Town of Hilton Head Island  
**Design Review Board Meeting**  
**Tuesday, July 27, 2021 – 1:15 p.m.**  
Benjamin M. Racusin Council Chambers

i. The Charles, DRB-001668-2021

i. St. Andrew By-The-Sea United Methodist Church Pope Avenue Entry, DRB-001654-2021

i. 15 Wimbledon Court, DRB-001665-2021

**DEMOLITION  
PLAN**

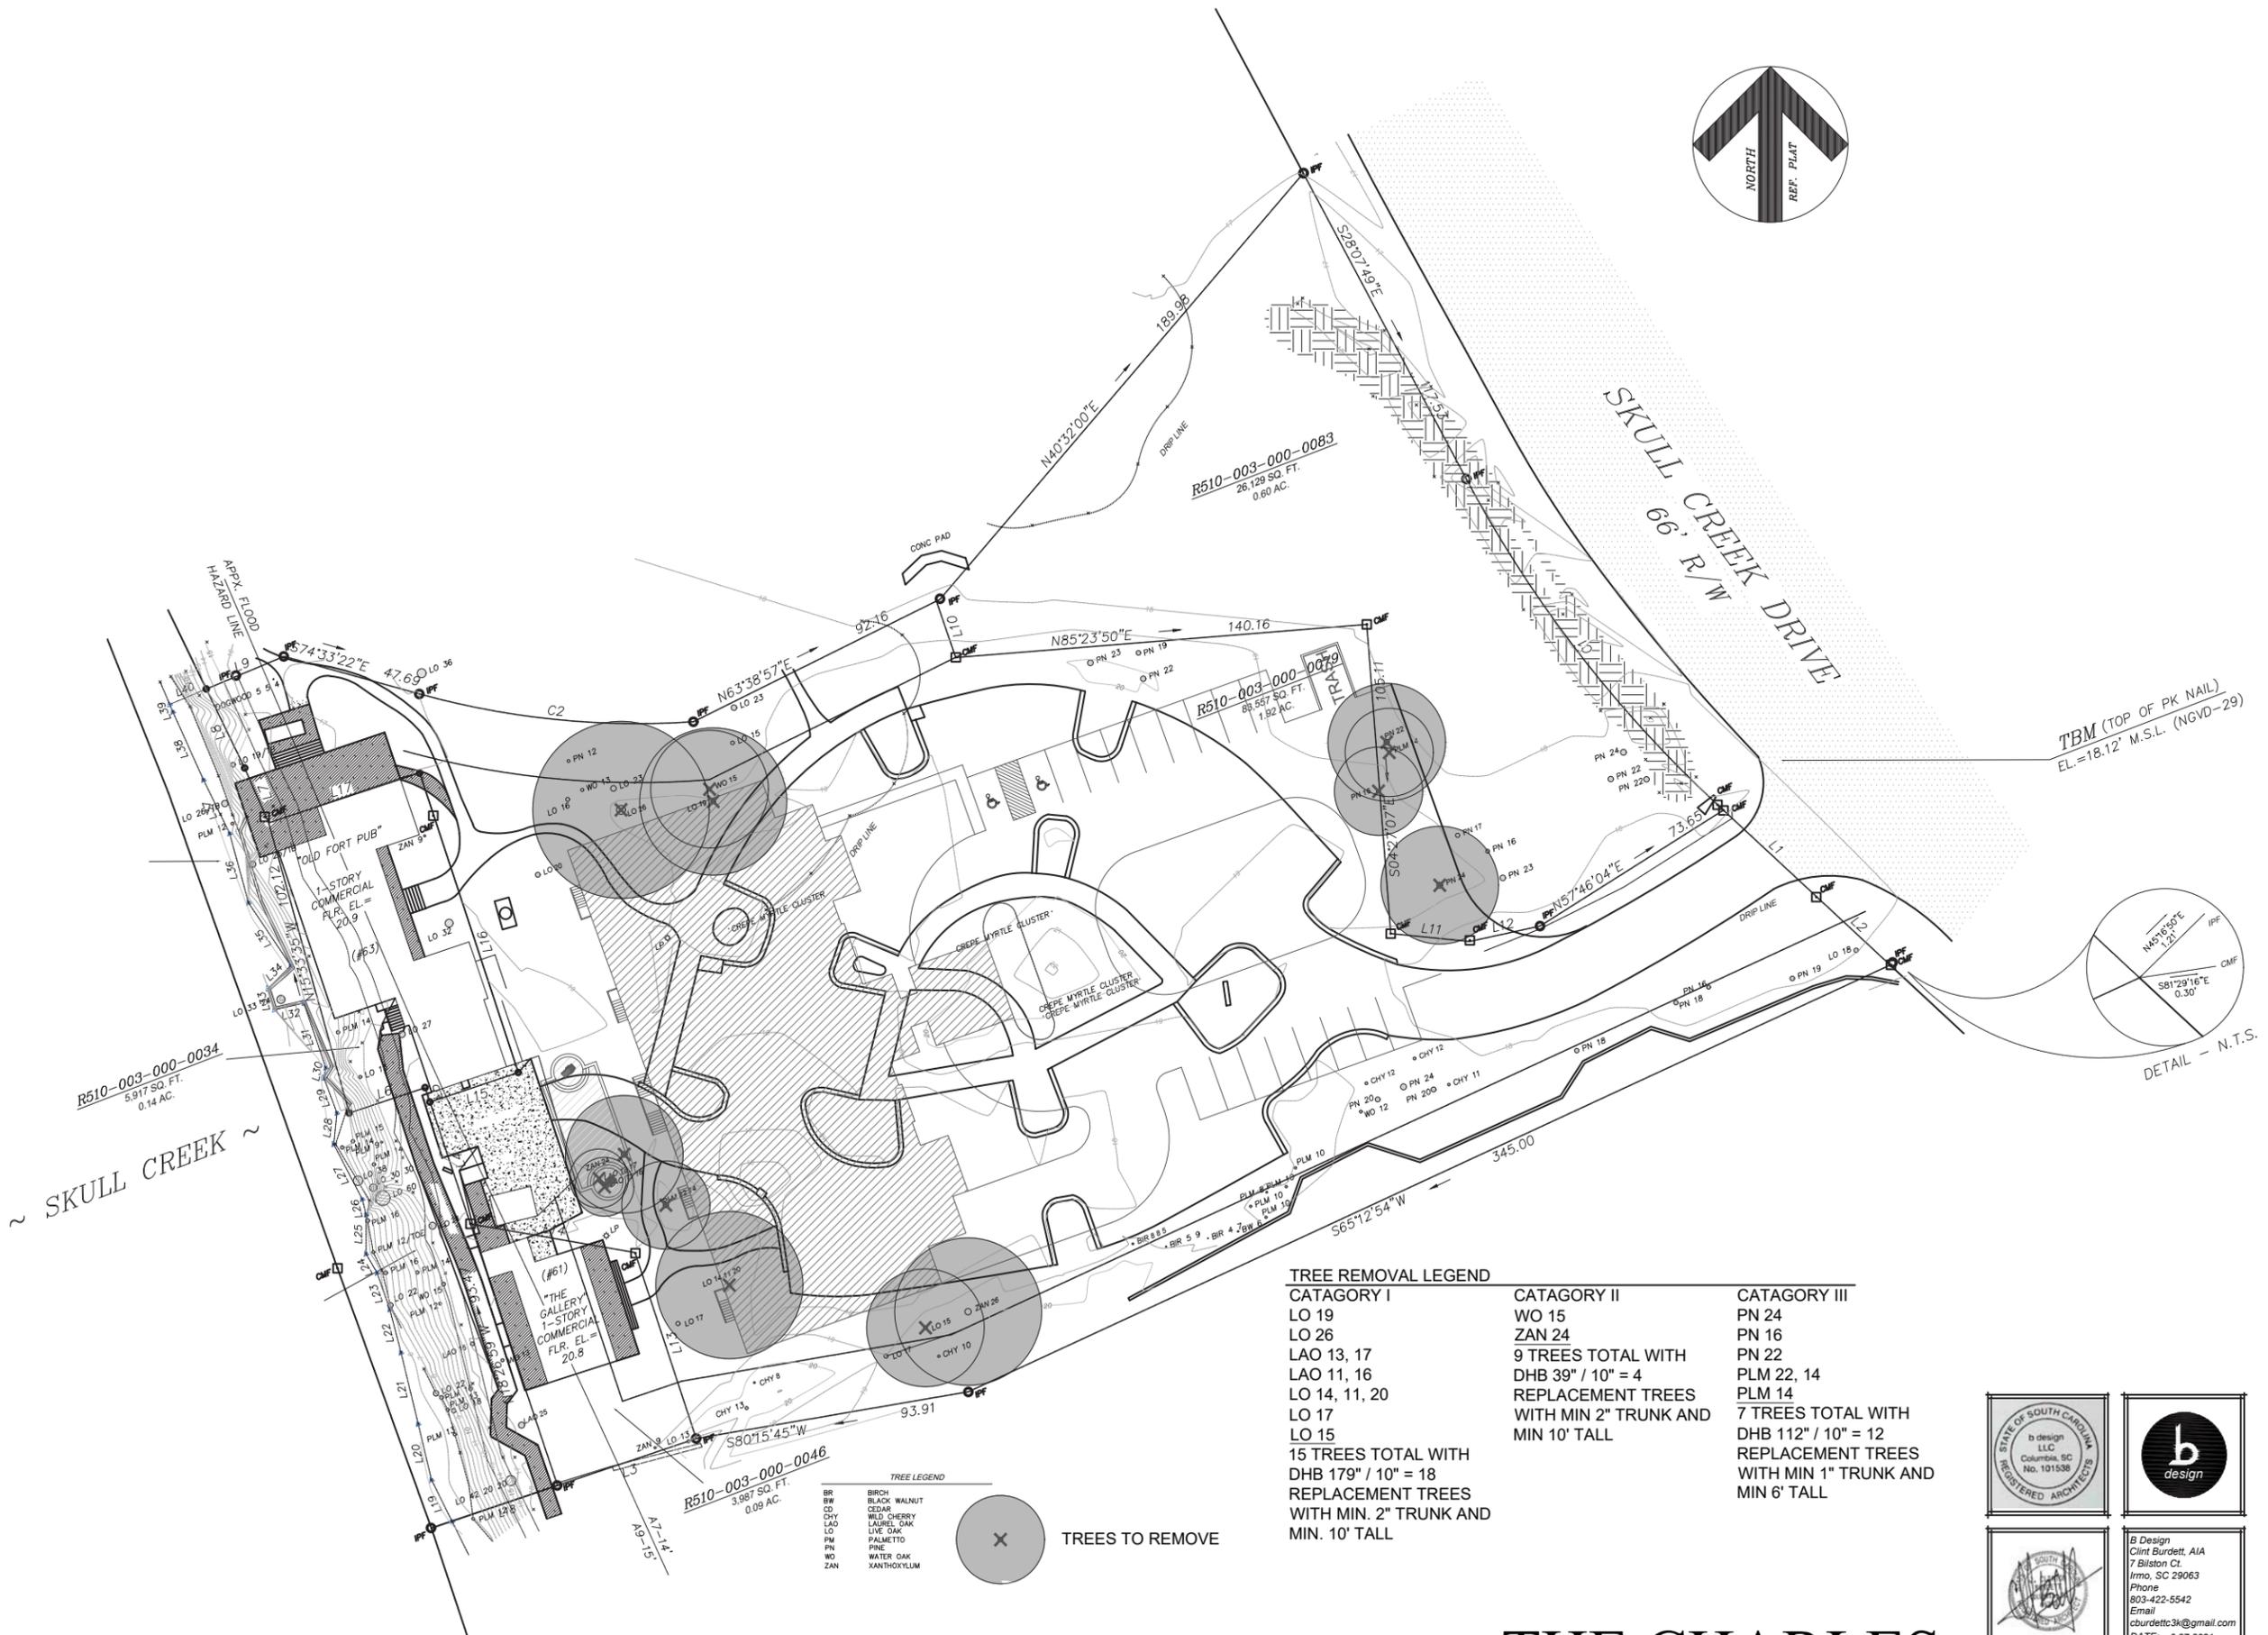
1. Provide a Demolition Plan
2. Provide a Tree Protection Plan specifying:
  - a. Preconstruction 4 – 6" mulch under canopy,
  - b. Pre and post fertilization and mycor treatments.
3. Revision of the Landscape Plan more in keeping with the scale of the development.
4. Provide an LMO compliant Lighting Plan.

**TREE PROTECTION & REMOVAL AND SEDIMENT & EROSION CONTROL PLAN**

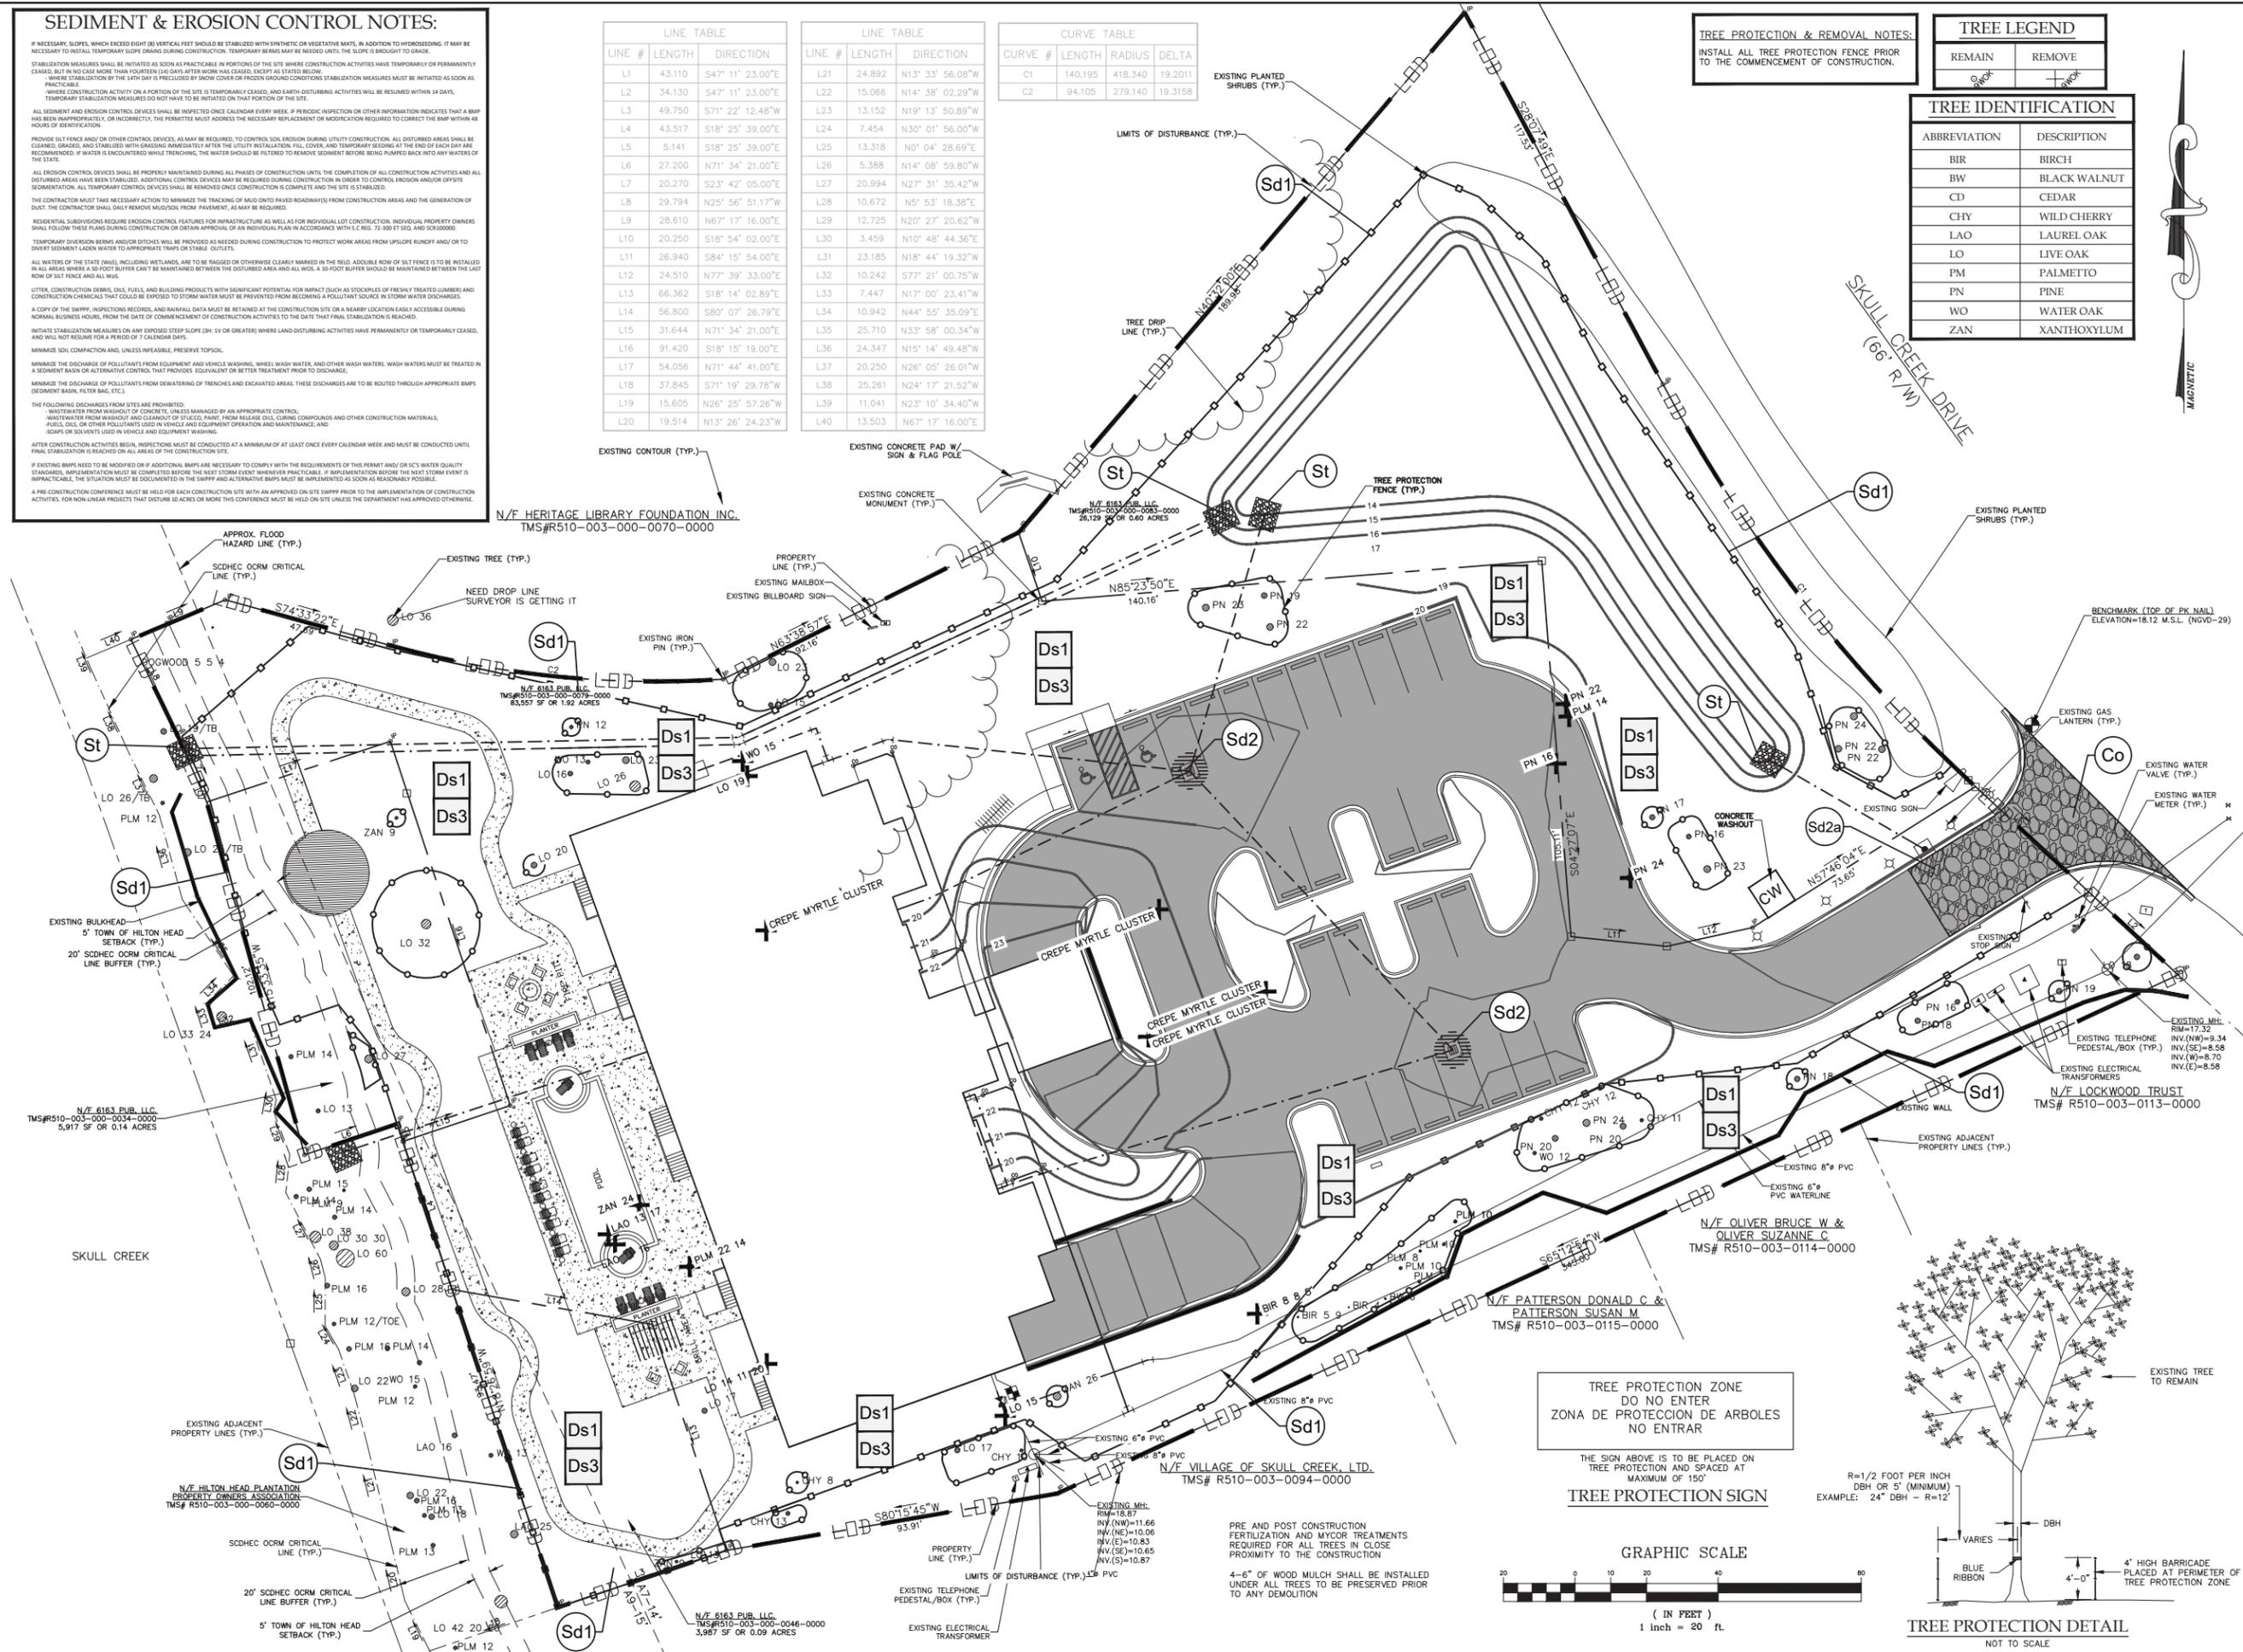
1. Given the 20” and 26” Live Oak location adjacent to the proposed building, provide a canopy study and relocation of the storm outfall.
2. Relocate the outfall into the lagoon to avoid the three pines north of the parking lot.
3. Revise the landscape plan to match the scope of the building.

DESIGN GUIDE/LMO CRITERIA	Complies Yes	No	Not Applicable	Comments or Conditions
An effort has been made to preserve existing trees and under story plants	<input type="checkbox"/>	<input checked="" type="checkbox"/>	<input type="checkbox"/>	Storm drainage line are too close to existing trees along the northern property line and at the lagoon outfall.

**MANSARD DETAIL 5TH FLOOR LOW ROOF**  
SCALE 1" = 1'-0"

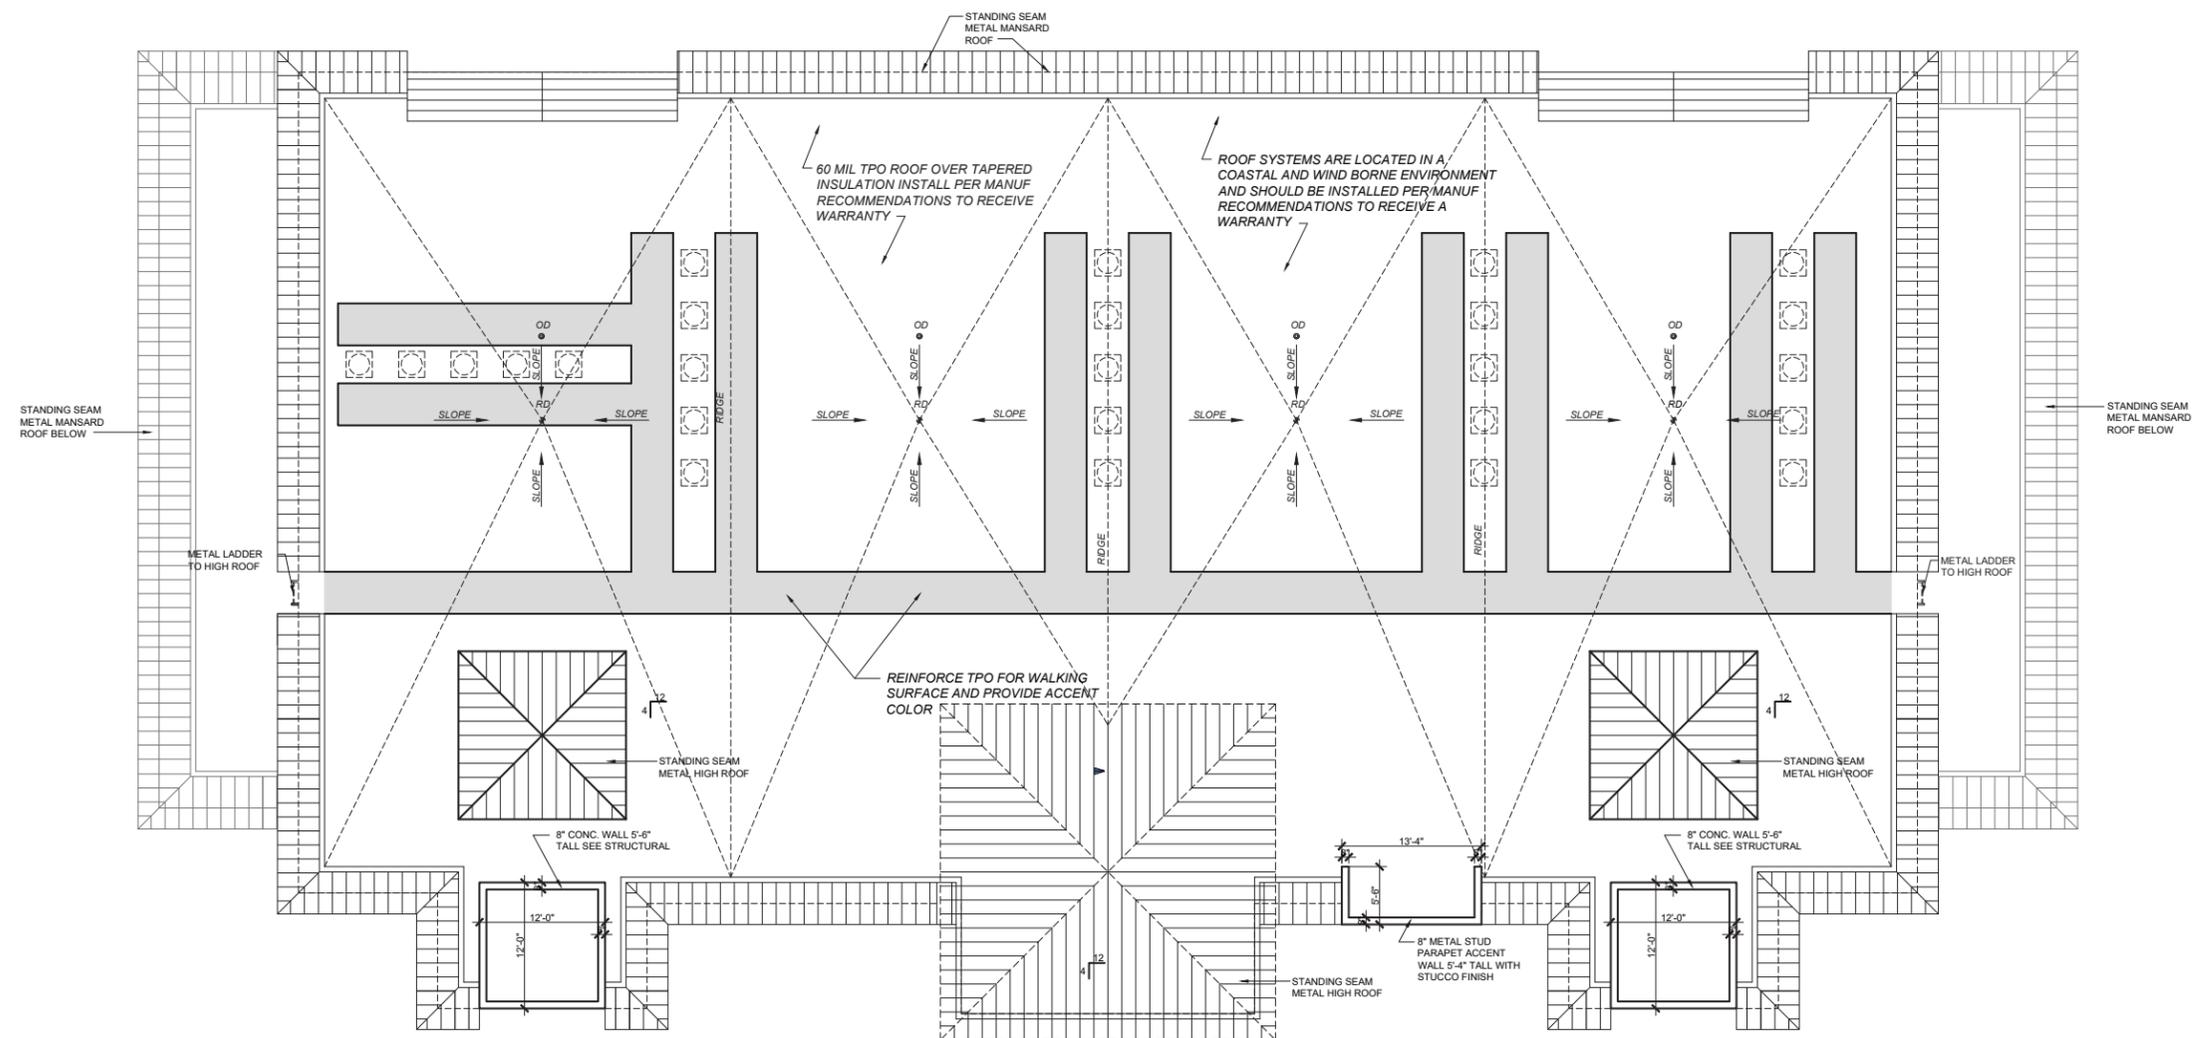
13. Delete the three gables on the side view.
14. Review bracket scale.
15. Provide a detail of the mansard roof as it comes past the tower.
